# Access Compliance Report

## Public Rights-of-Way

Intersection ID: 11256	Main Street: N_IRWIN_AV	Cross Street: W_5TH_ST	Location: N
ADA ID: 93A93E7625B6	Ramp Type: BlendTrans1	Initial Pass/Fail: Fail	Overall Compliance: No
		Severity Score: 12.5

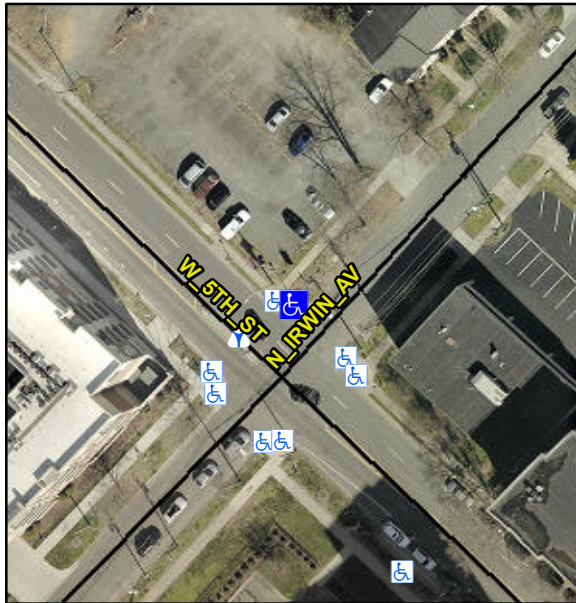
**NO LNDG**

**Not Found, R304.5.3**

**Remove & Replace Curb Ramp With Two New Directional Ramps or Equivalent.**
